Planning and Zoning Commission - Regular Meeting AGENDA

Tuesday, September 15, 2020 at 4:30 PM
Ketchum City Hall
480 East Avenue North, Ketchum, ID 83340

STAFF REPORT
KETCHUM PLANNING AND ZONING COMMISSION
MEETING OF SEPTEMBER 15, 2020

- PROJECT: 4th & Walnut Ave Commercial Development Design Review
- FILE NUMBER: P20-046
- APPLICATION TYPE: Design Review
- APPLICANT: Graham Whipple, Resin Architecture
- PROPERTY OWNER: Walnut & Fourth LLC
- LOCATION: 371 & 391 N Walnut Avenue (Ketchum Townsite: Block 44: Lots 7 & 8)
- ZONING DISTRICT: Retail Core Subdistrict of the Community Core (CC-1)
- NOTICE: The public hearing for this application was continued from the July 13th and August 11th Planning & Zoning Commission Meetings. The project was re-noticed for the public hearing scheduled on the agenda for the September 15th Planning & Zoning Commission Meeting. The public hearing notice for this project was mailed to all owners of property within 300 feet of the project site and published in the Idaho Mountain Express on August 26th, 2020.
- REVIEWER: Abby Rivin, Associate Planner

1 Colored Nest Elevation
SCALE: 1:1,649

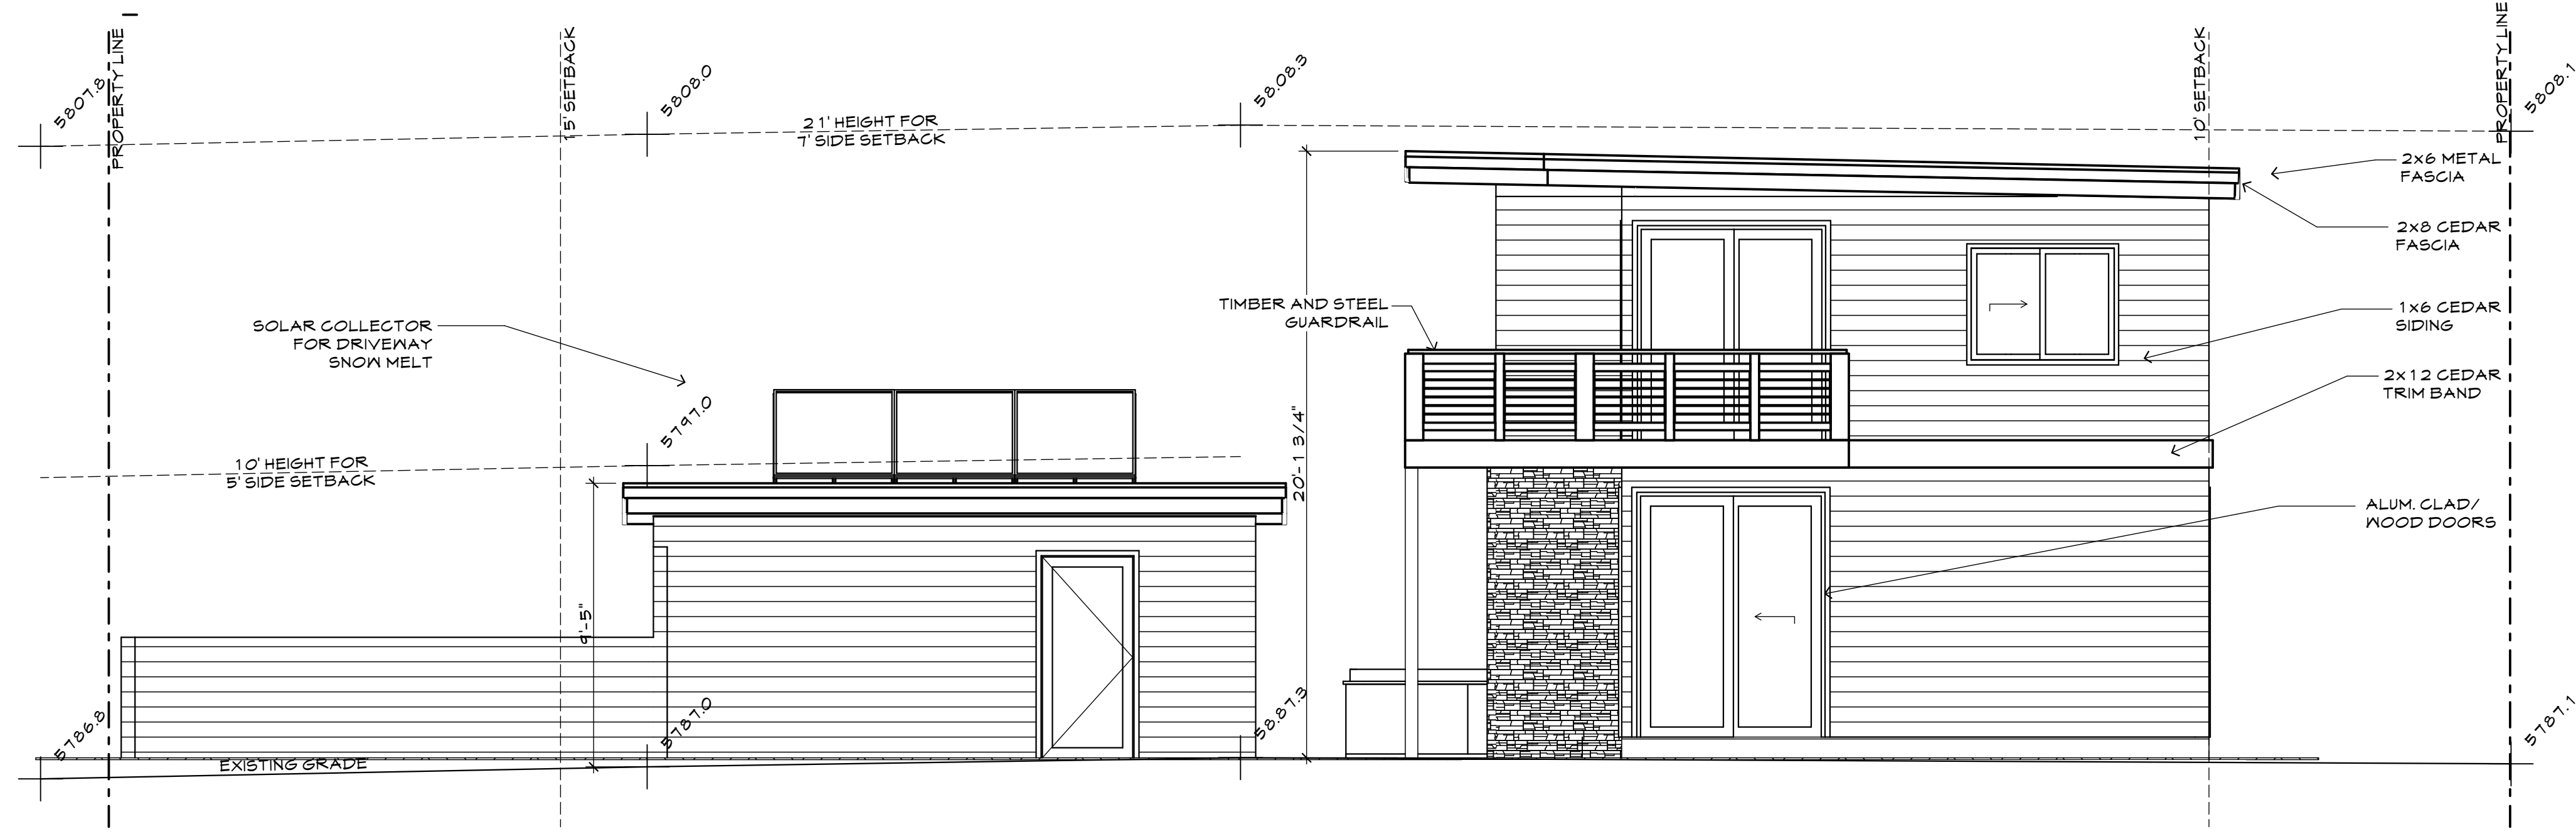
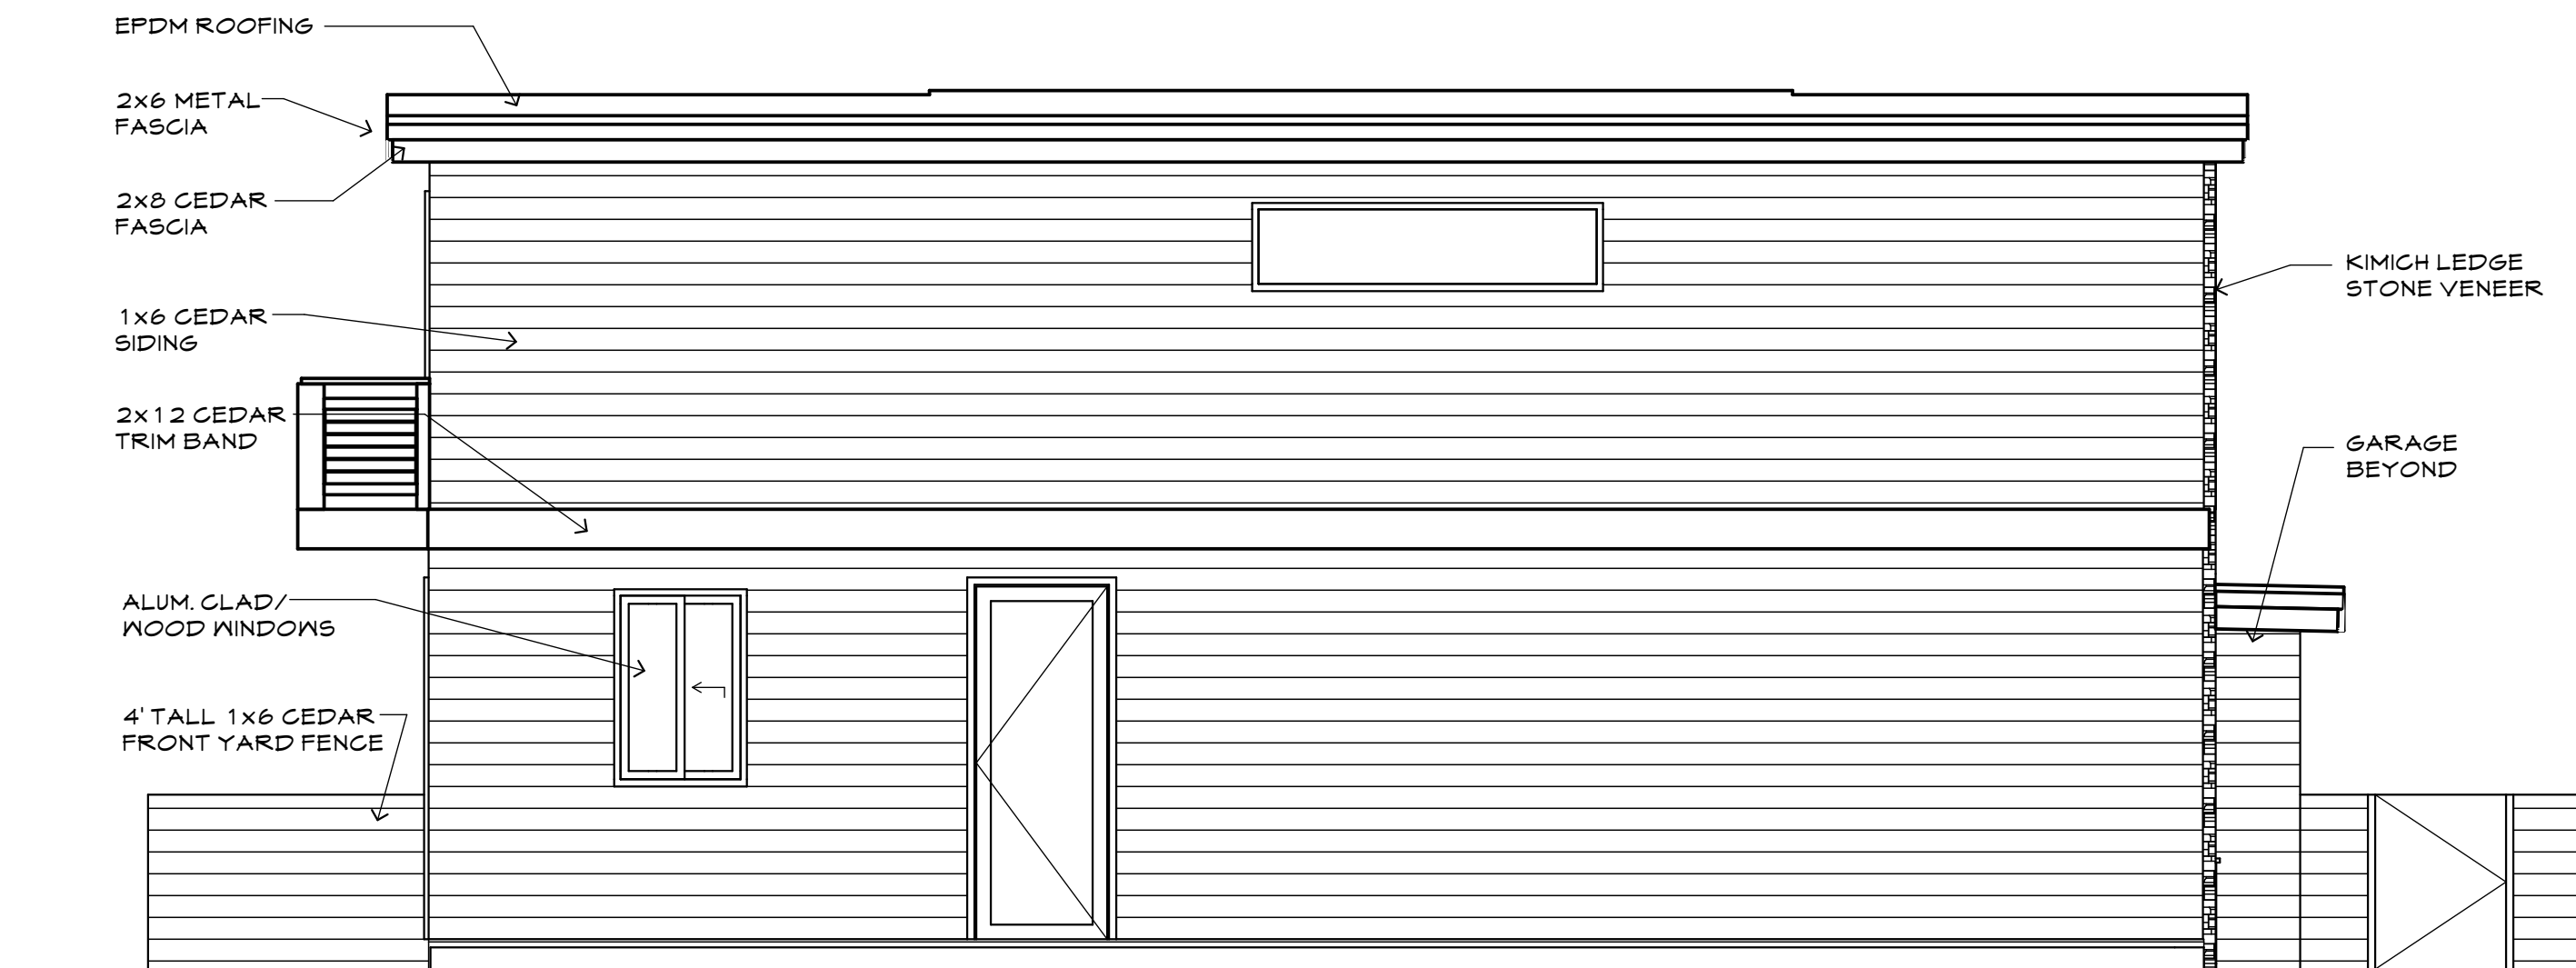
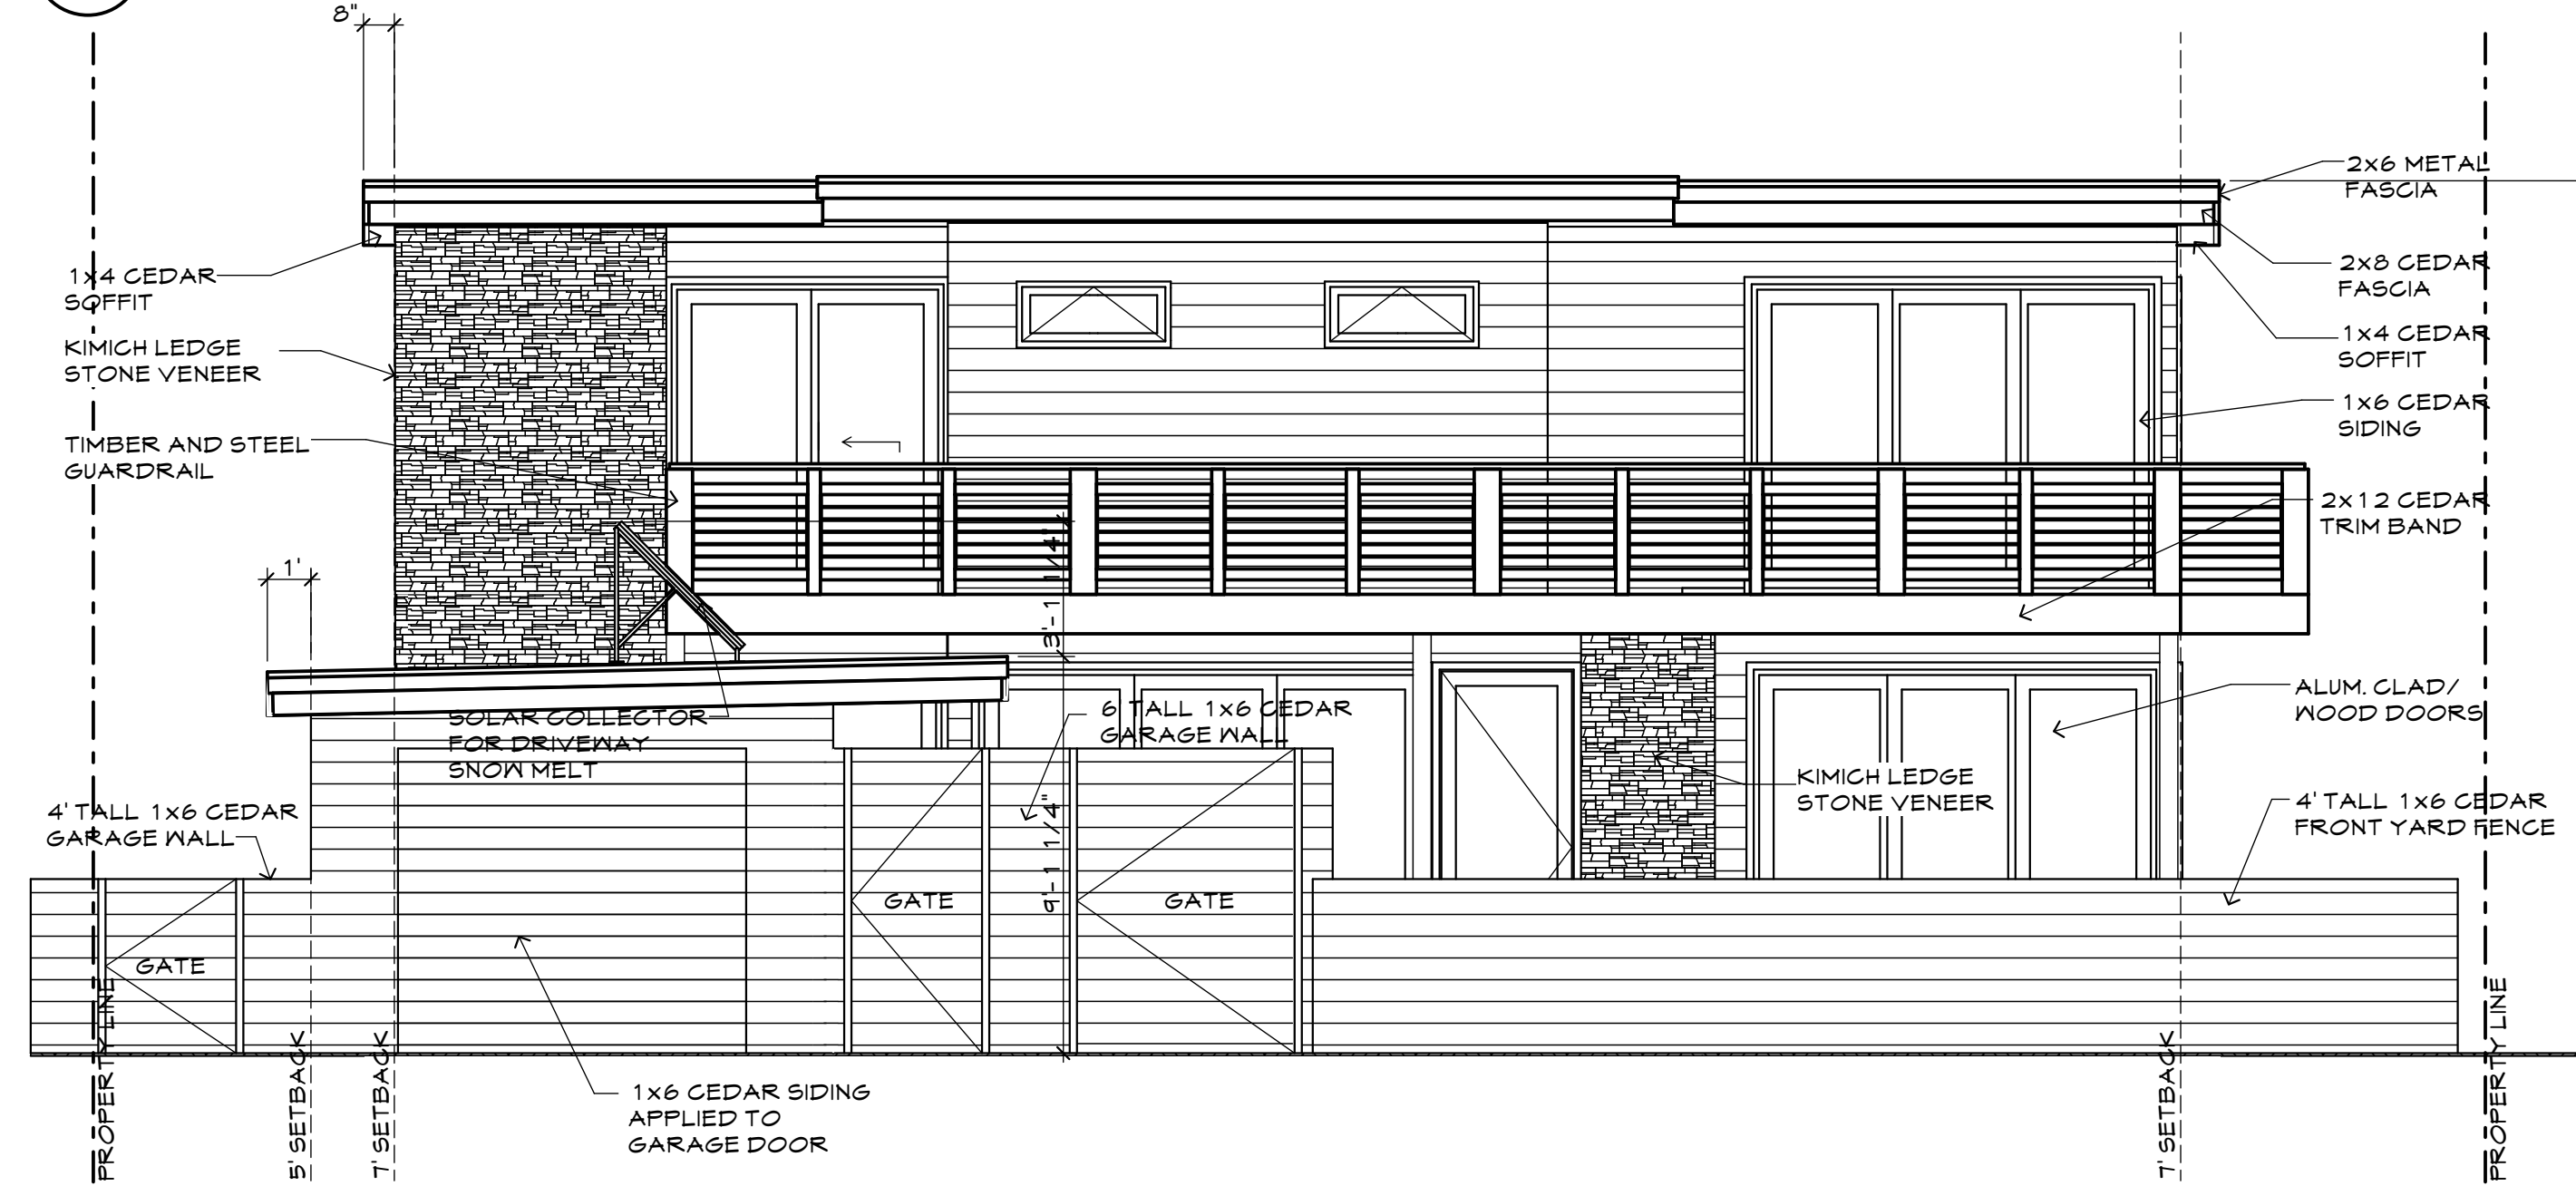
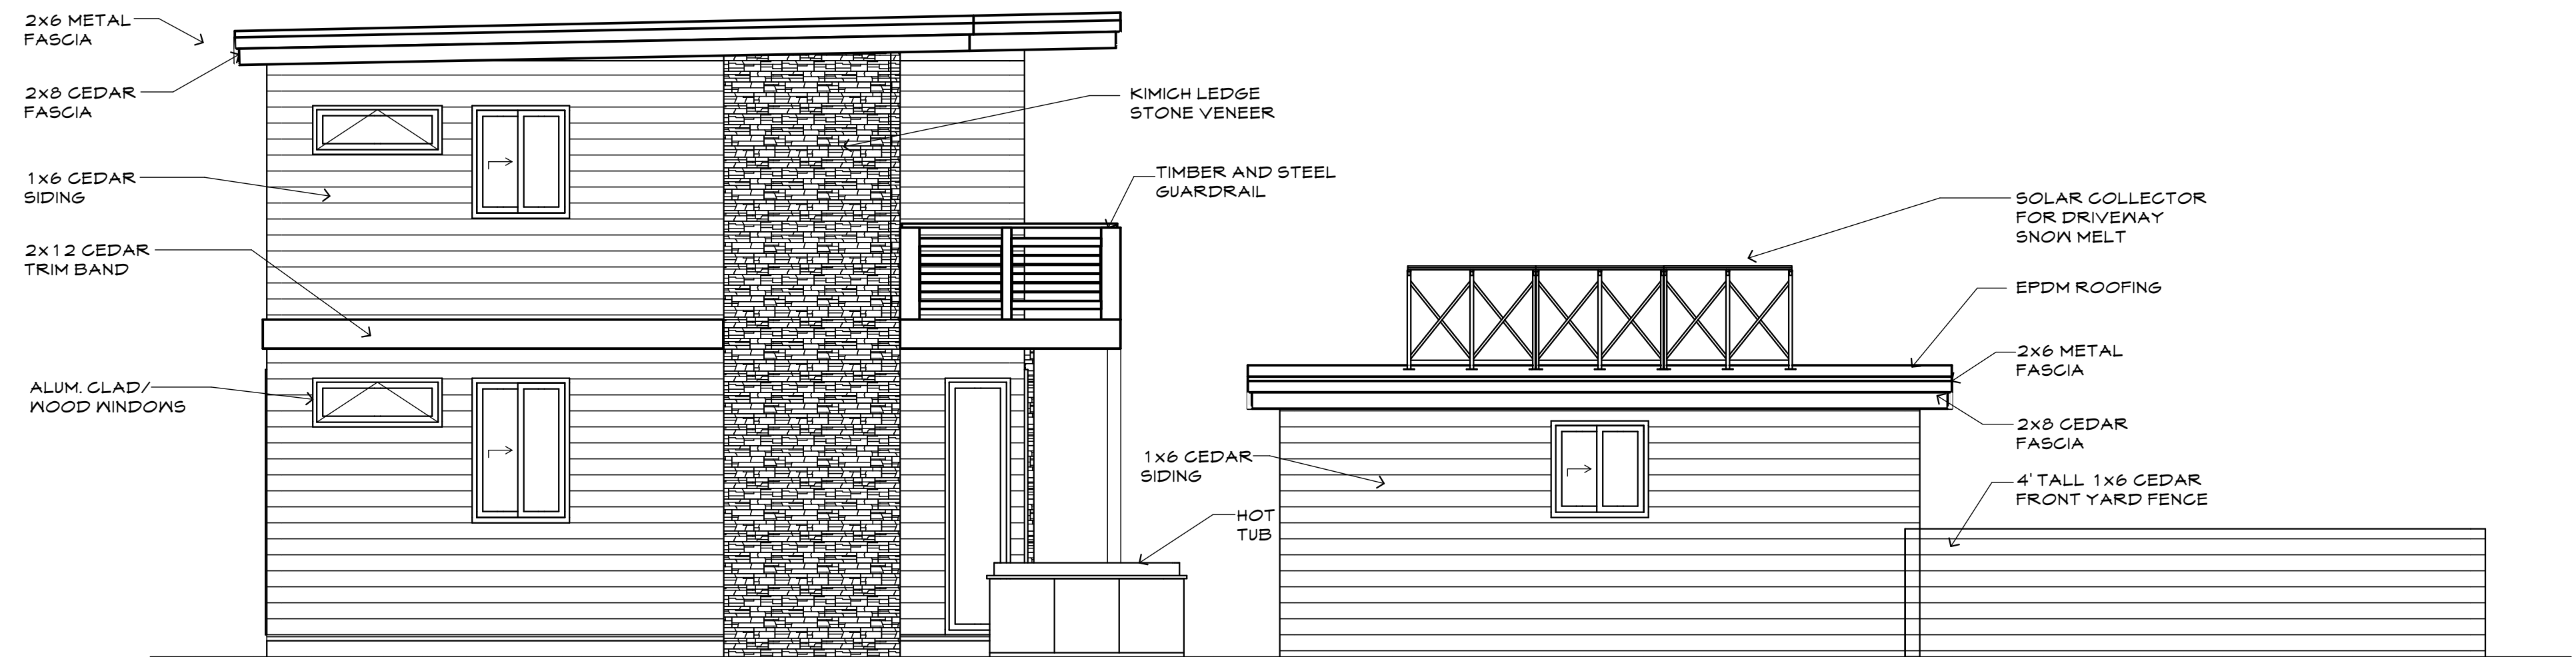
The elevations on Sheet 5 of the project plans note the exterior materials. The applicant has provided one colored elevation illustrating the front façade. Pictures and specifications of the proposed exterior materials have also been included in the project plans. The design utilizes natural materials and colors, like cedar siding and stone veneer, which complement the home's mountainous surroundings. The neighboring townhome on subplot 2 is also characterized by natural materials and colors. The proposed townhome on subplot 1 has a darker color palette with predominately reddish-brown stained cedar and black trim. The existing townhome on subplot 2 has a lighter color palette with gray-tinted beige stone veneer and khaki-tan stucco with dark brown vertical siding and trim. The project's materials and colors complement the surrounding neighborhood's design style. Homes in West Ketchum use natural materials and simple geometric designs characteristic of an alpine setting.

<i>Staff Comments</i>	<i>Building elevations are included on Sheet 5 of the project plans. Two-story and one-story elements of stone veneer provide relief from the horizontal cedar siding. The two-floors of the townhome unit are visually distinguished by the second-level balcony at the front elevation and a cedar trim band wrapping across all facades. Black aluminum-clad window and door openings, metal fascia, and the balcony's railing detail provide further relief from the horizontal cedar siding. The slight slope of the mono-pitched roof decreases the bulk of the box-shaped building.</i>
<input checked="" type="checkbox"/>	<input type="checkbox"/>	<input type="checkbox"/>	17.96.060.F3 Architectural	There shall be continuity of materials, colors and signing within the project.
			<i>Staff Comments</i>	<i>The detached garage and fence match the townhome's materials and colors. The detached garage utilizes the horizontal cedar siding, metal fascia, and black aluminum-clad windows and doors. The townhome unit and detached garage have a consistent design theme with matching materials and colors.</i>
